SIMPSON-GLENDALE BAR; CA MINE ID #TBD, CUP-16-204, SMP-16-003  
NEW RECLAMATION PLAN

TRINITY VALLEY CONSULTING ENGINEERS, INC.

RE: Response to California Division of Mine Reclamation Comments dated August 30, 2017  
Simpson Glendale Bar New Reclamation Plan  
CA Mine ID #TBD, CUP-16-204, SMP-16-003

**PLOT PLAN**  
 GR SUNDBERG INC  
 1226 GLENDALE DR  
 APR 504-131-04  
 PLUMBLIST COUNTY - CALIFORNIA

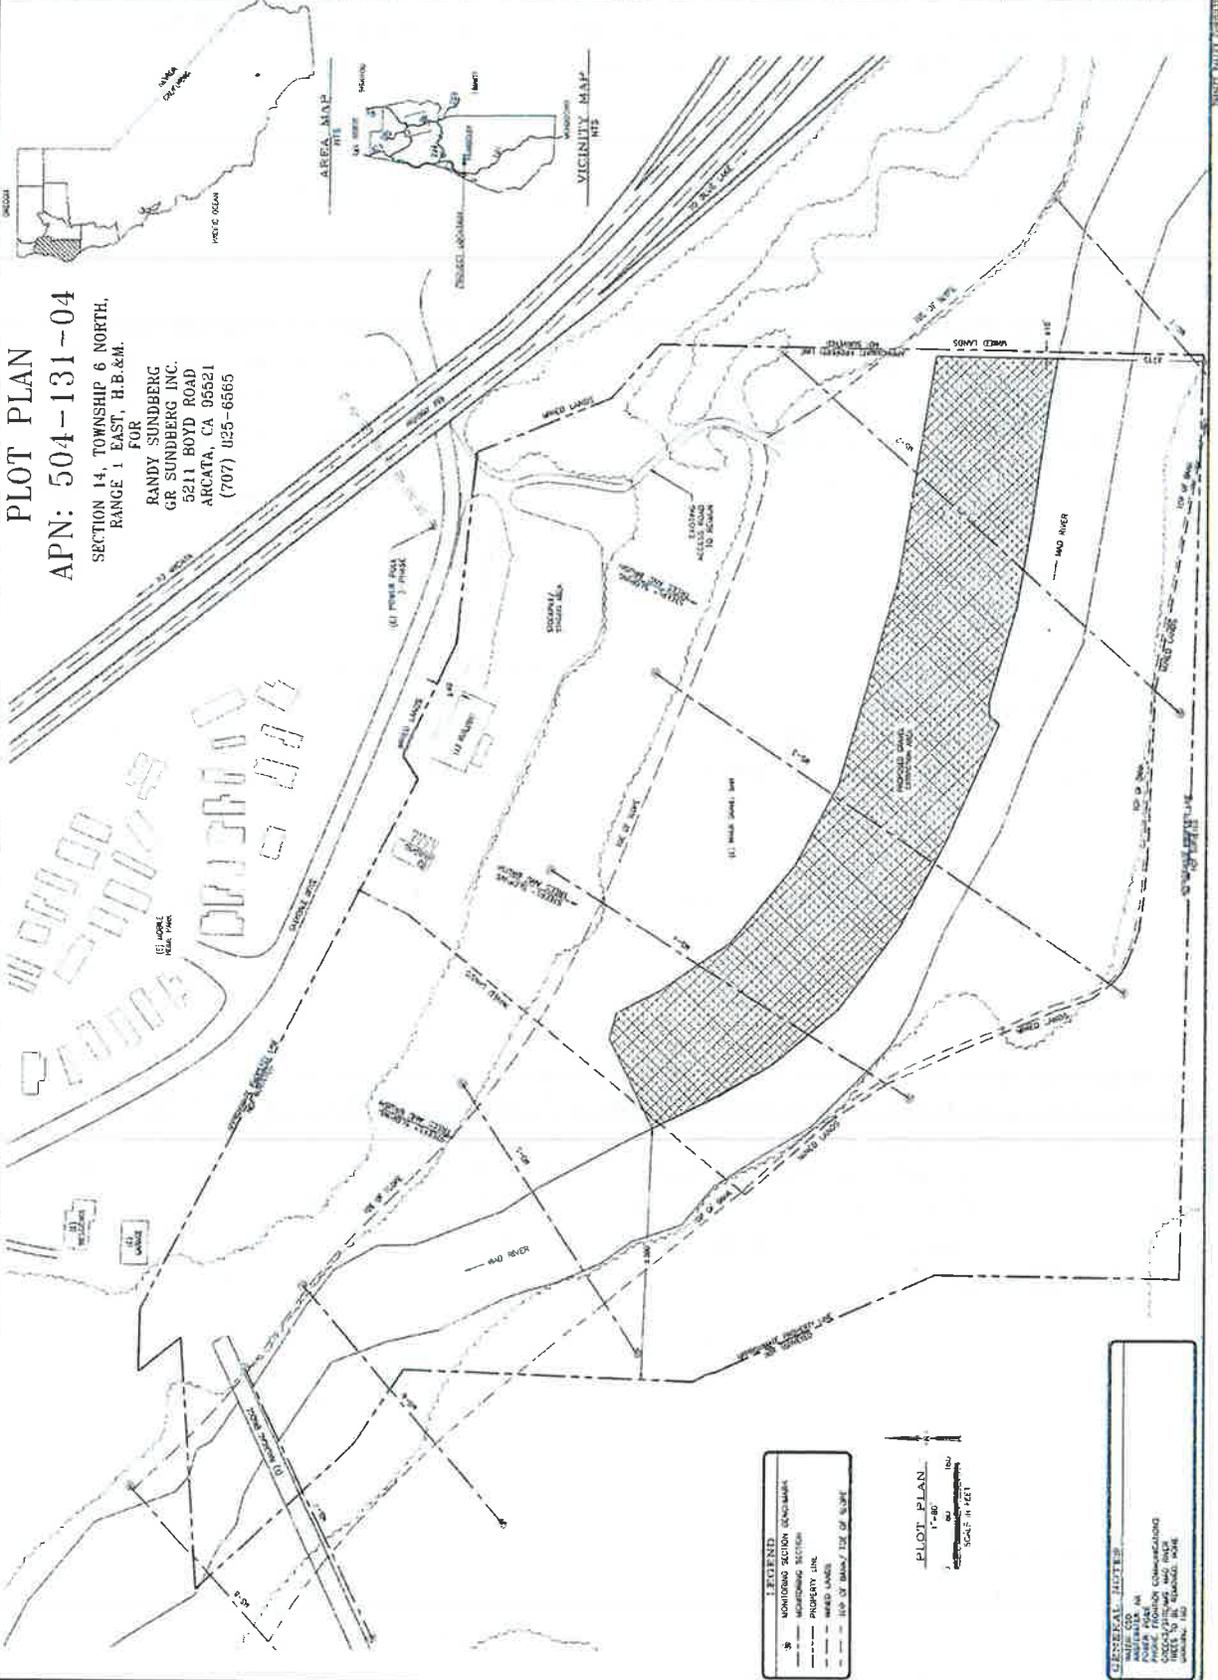
The RP states that the applicant will stockpile extracted minerals on a two-acre area located adjacent to the extraction area and above the floodplain. According to PRC Section 2729, this area will be a part of the surface mining operation's "mined lands". Therefore, the RP should describe the proposed use or potential uses of the mined lands after reclamation a.k.a. the "end use" for this area pursuant to PRC Section 2772(c)(7). Additionally, the RP should describe reclamation that may be required for this area in accordance with SMARA and associated regulations.

The *Plot Plan*, prepared by Trinity Valley Consulting Engineers (TVCE) and dated March 2017, only illustrates a "Proposed Gravel Extraction Area". We acknowledge that the shape of the gravel bar will change because it is part of an active surface mining operation and lies within an active geomorphic environment. However, pursuant to PRC 2772(c)(5)(B), the maps should include a reclamation plan boundary encompassing the "mined lands"-all areas that will potentially be impacted by the surface mining operation and require reclamation, including extraction and stockpile areas. Additionally, if the applicant plans to operate on the far (southwest) side of the river, the reclamation plan boundary should also encompass those areas.

The *Plot Plan* depicts an access road from the stockpile area to the gravel bar. To avoid confusion, we recommend that the RP clearly distinguish temporary roads to be reclaimed from any roads remaining for the approved end use (pursuant to PRC 2772(c)(5)(E)).

We acknowledge that a portion of the surface mining operation will be located in a river (an active geomorphic environment) where the ground surface is in constant flux. However, areas of the operation outside of the influence of the river generally have static topographic features both at the time of permitting and at reclamation. Therefore, pursuant to PRC Section 2772(c)(5)(C), maps included in the RP should illustrate existing and final topography for mined lands outside of the influence of the river.

**Please see revised project map indicating the location of the stock pile area. Currently the area proposed for the stock pile area is a graded flat located adjacent to an existing graveled flat utilized for parking and storage. Reclamation of the proposed stock pile site shall consist of retuning the site to its current condition as a gravel flat no further reclamation activities are required.**

**Please see revised project map indicating the boundaries “Mined Lands”**

**Please see revised project map indicating the access road that “shall remain in place” following reclamation activities**

**Please see revised project map indicating existing topography outside the river current area of influence**
